SHINE TECHNOLOGIES, LLC

**SHINE TECHNOLOGIES, LLC APPLICATION FOR AN OPERATING LICENSE SUPPLEMENT NO. 15
SUBMITTAL OF THE PHASED STARTUP OPERATIONS APPLICATION SUPPLEMENT**

**SHINE PHASED STARTUP OPERATIONS APPLICATION SUPPLEMENT
(PUBLIC VERSION)**

**Figure 6a2.2-1 – Tritium Confinement Boundary
(Sheet 1 of 2)**

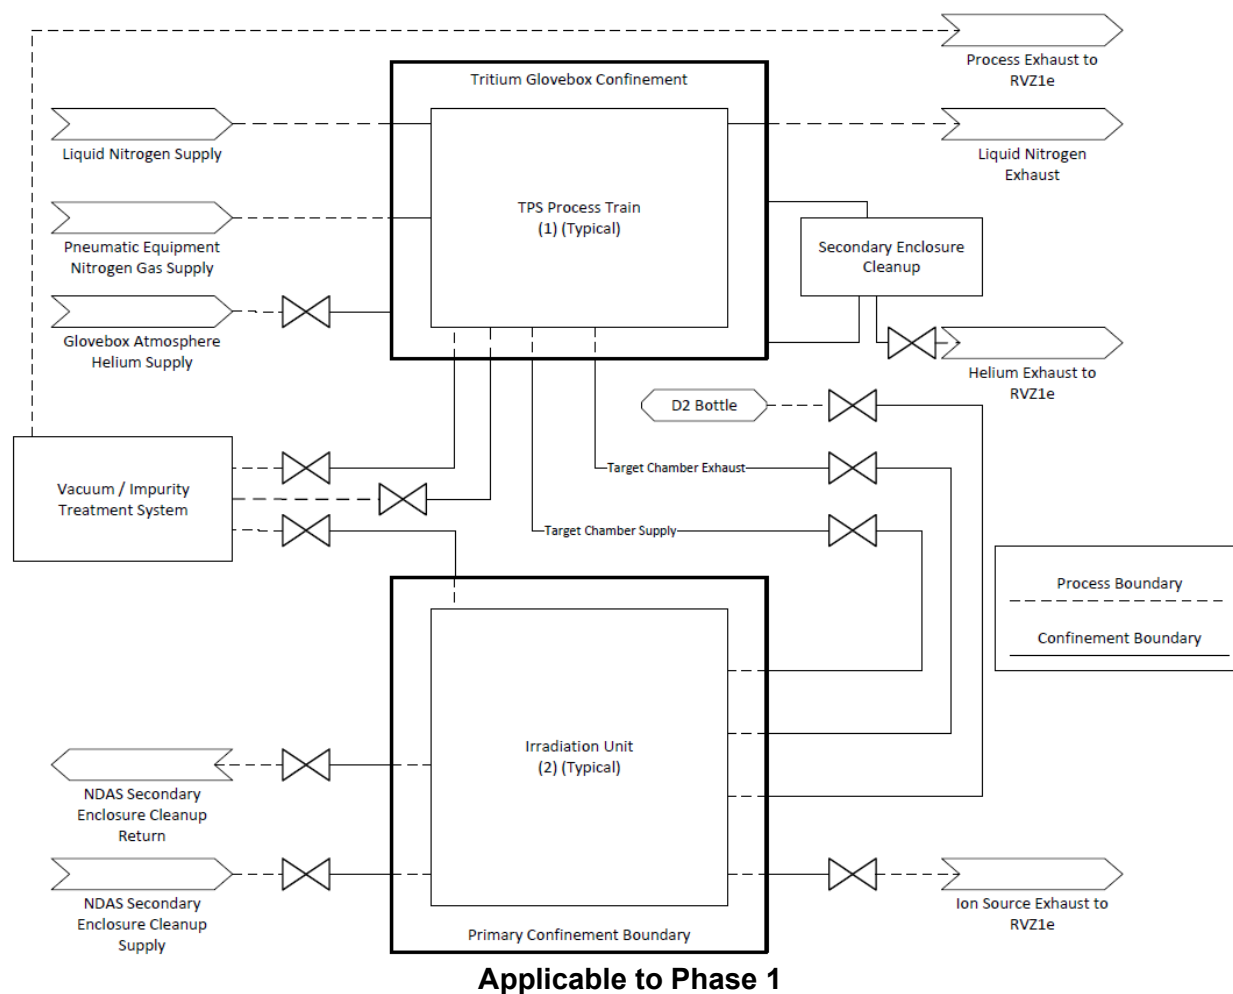
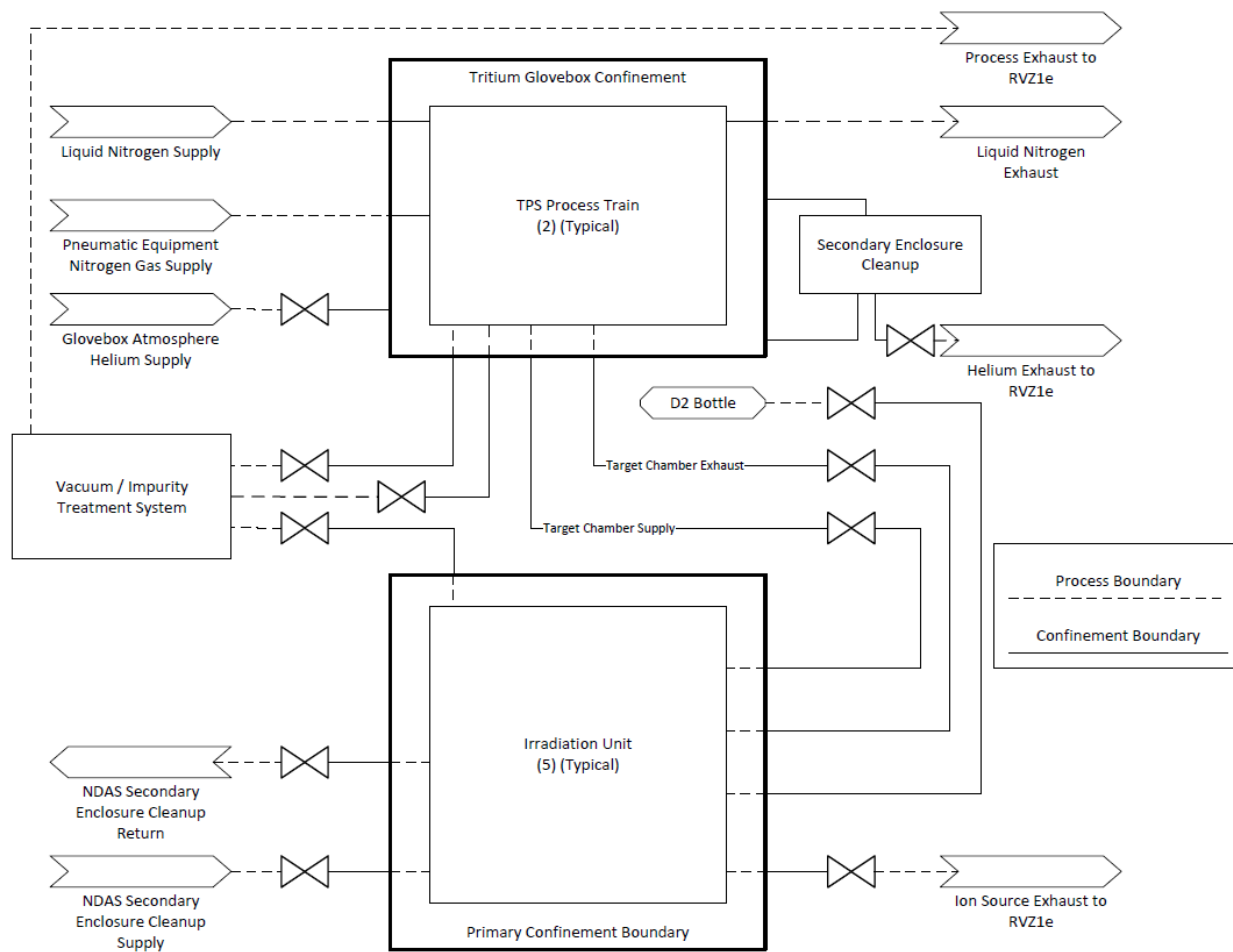
Figure 6a2.2-2 of the FSAR is not impacted by the phased startup operations with the exception of the number of TPS process trains and irradiation units present in each phase. Figure 6a2.2-1 provides an update to Figure 6a2.2-2 of the FSAR to reflect the number of TPS trains and IUs in operation during Phase 1 and Phase 2.

Figure 6b.2-1 – Supercell Confinement Boundary

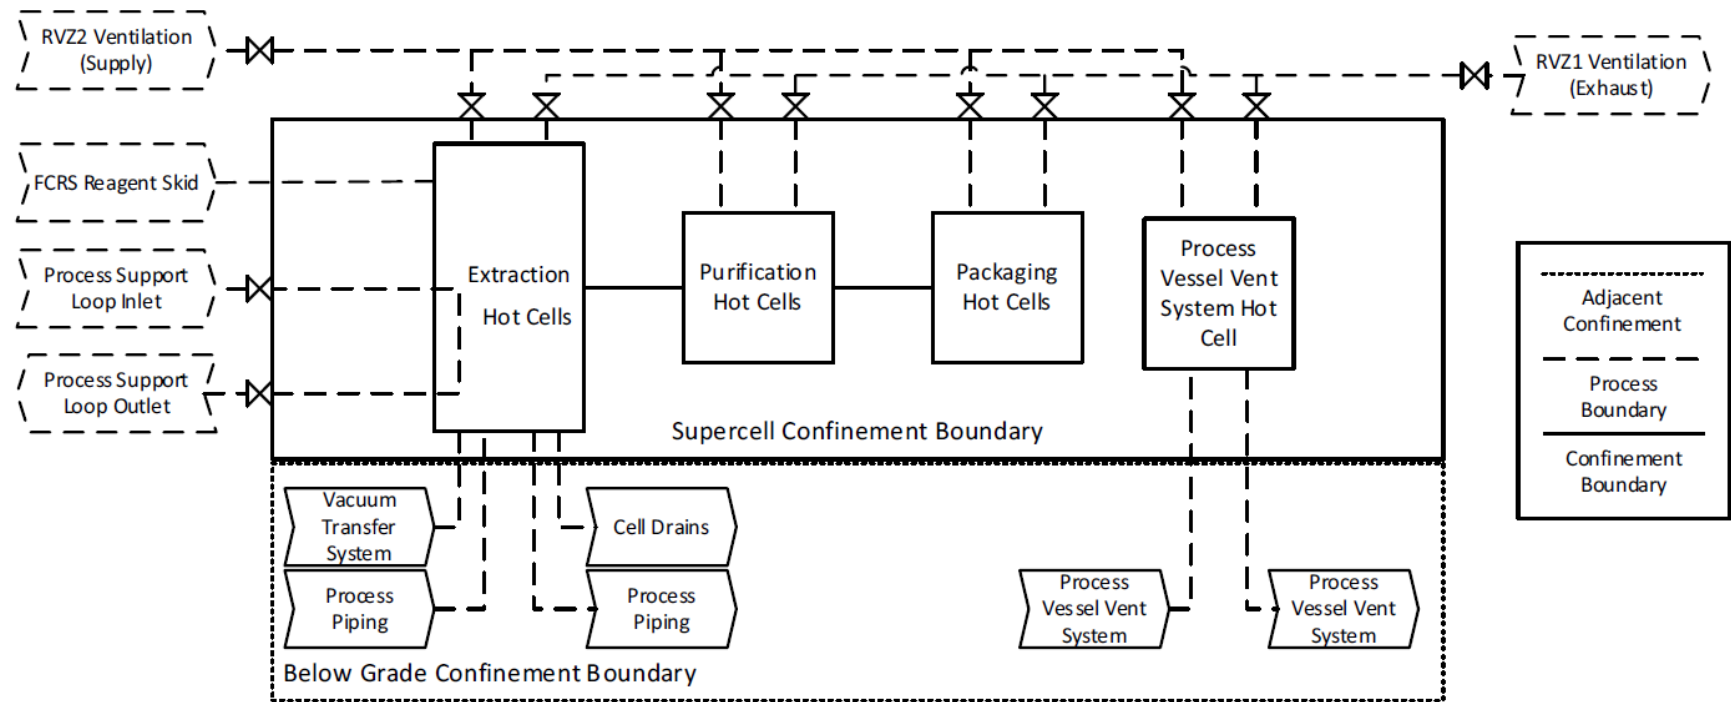
The iodine and xenon purification and packaging (IXP) system equipment is not installed as part of Phase 1, 2, or 3 operations. To support installation of this system for Phase 4, the IXP hot cell is not part of the supercell confinement in Phase 1, 2, and 3 operations. Structures, systems, and components (SSCs) are installed to isolate any connections to the IXP from other installed systems. Isolation is maintained between the IXP cell and the other hot cells using the bubble tight dampers shown in Figure 9a2.1-3 of the FSAR. These dampers remain closed until the IXP cell is in operation to maintain the supercell confinement boundary. Figure 6b.2-1 provides a block diagram of the supercell confinement boundary in Phases 1, 2, and 3.

Figure 6b.2-1 provides a block diagram of the supercell confinement boundary applicable to Phase 1, 2, and 3 operations.

Figure 6b.3-1 – Radioactive Liquid Waste System Overview

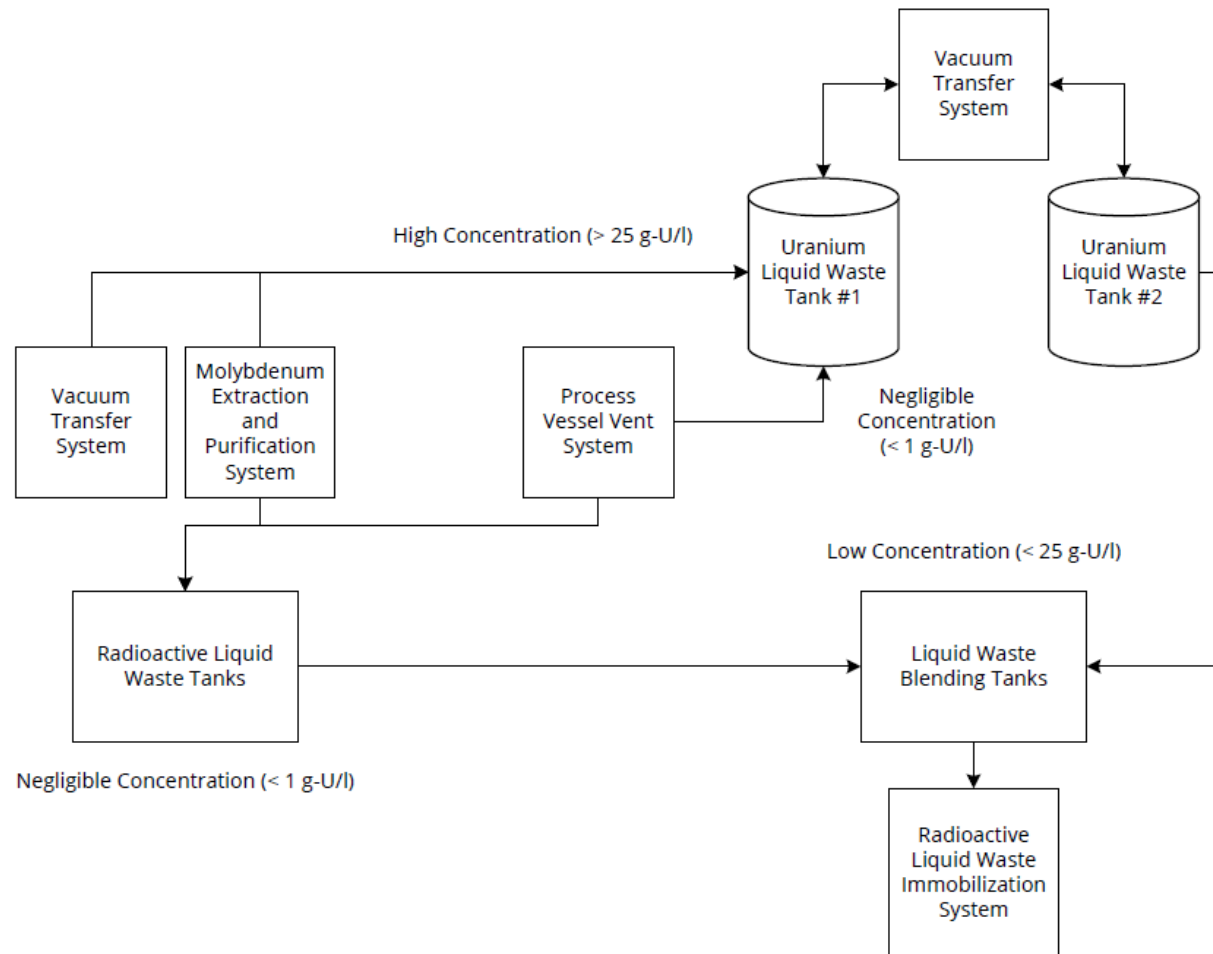
To reflect installation of the IXP system to support Phase 4 operation, Figures 6b.3-1, 6b.3-2, and 6b.3-3 provide system overviews of the radioactive liquid waste storage (RLWS) system, the molybdenum extraction and purification system (MEPS), and the radioactive drain system (RDS), respectively, in Phases 1, 2, and 3. The Phase 1, 2, and 3 system overviews provided in Figures 6b.3-1, 6b.3-2, and 6b.3-3 provide configuration updates to the system overviews
